UNITED STATES PATENT AND TRADEMARK OFFICE

10/587,451

Office Action Summary	Application No. 10/587,451	Applicant(s) AMANO, RYUICHIRO	
	Examiner NATHAN ZOLLINGER	Art Unit 3746

Detailed Action

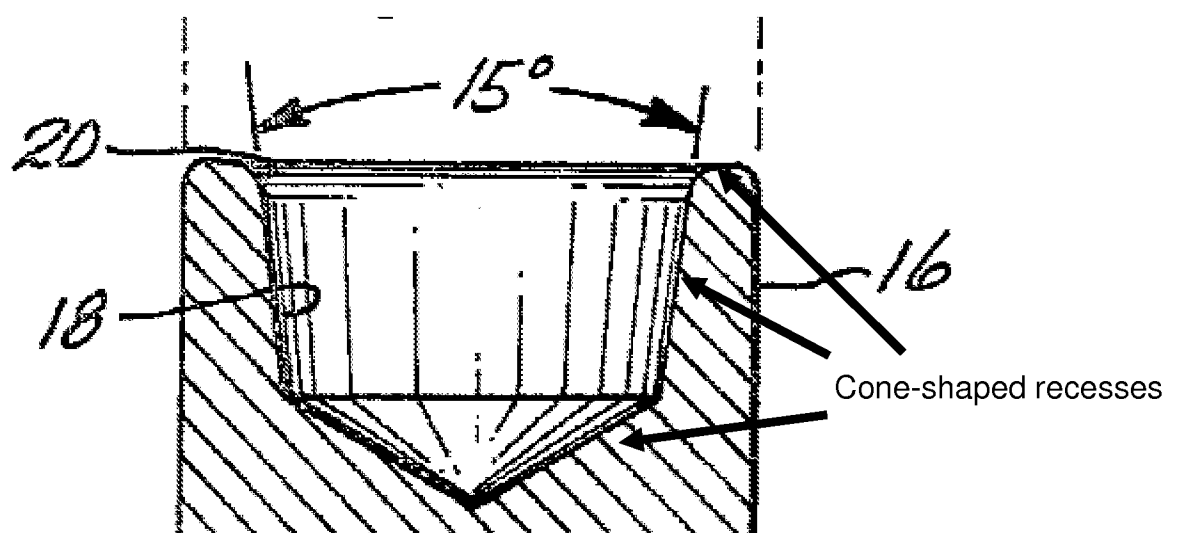
Claim 5: Hufnagl discloses a method of plate installation comprising mounting a plate member (24) on a supporting base plate (12 OR 12 & 26) by fitting a projection (16) of the supporting base plate into a through hole (28) of the plate member to project a top end part of the projection from the through hole, the supporting base plate having a projection with a cone-shaped recess (Examiner notes several candidates depicted

below which are on an “upper face” of the projection) on an upper face of the projection; and crushing (Fig. 4) a projected part of the projection from the through hole except for a portion of the cone-shaped recess on the projection by applying a downward pressing force to the projected part so as to integrate the plate member with the supporting base plate such that a bottom portion of the cone-shaped recess exists in a state of the projection being crushed (Fig. 4). Hufnagl also discloses a cone-shaped recess having an opening diameter of about 50% of an outer diameter of the projection and a depth of 10 to 15 % of the outer diameter of the projection (Examiner chooses the bottommost recess which is about 50% of the OD and which has a depth of around 15% the OD).

FIGURE 3

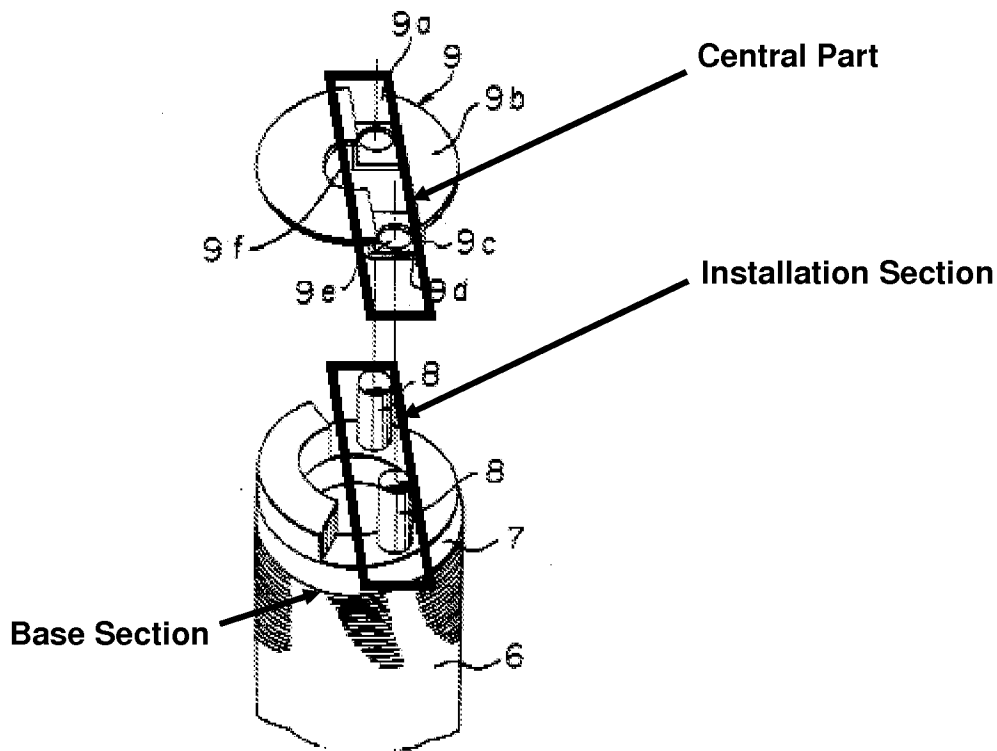
Muramatsu also does not disclose a projection with a cone-shaped recess with a diameter that gradually decreases downward on an upper face of the projection. Hufnagl teaches connection device in which a rivet projection possesses a cone-shaped recess that gradually decreases downward on an upper face of a projection (Examiner notes several candidates depicted above). It would have been obvious at the time the invention was made to a person having ordinary skill in the art to employ a cone-shaped recess as taught by Hufnagl in order to limit the outward pressure of the projection upon the clamped body (in the case of Muramatsu, it would be the separation plate; see col. 1, lines 55-58). Hufnagl also discloses a cone-shaped recess having an opening diameter of about 50% of an outer diameter of the projection and a depth of 10 to 15 % of the outer diameter of the projection (Examiner chooses the bottommost recess which is about 50% of the OD and which has a depth of around 15% the OD).
